Public Advisory Group
Special Session
on Analysis for 2018 IRP

**Outstanding Unresolved Issues
as of January 11, 2018**

EPE's response to Outstanding Unresolved Issues presentation.

Net Generation, Exclusive of Plant Use - MWh

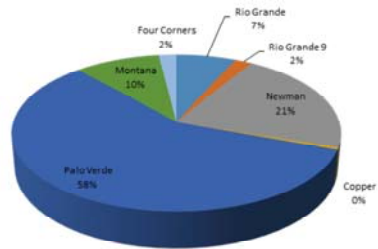
Ancillary value for operating hours must be limited to available need, and alternate price, including Purchased Power (per FERC 2016 \$.026)
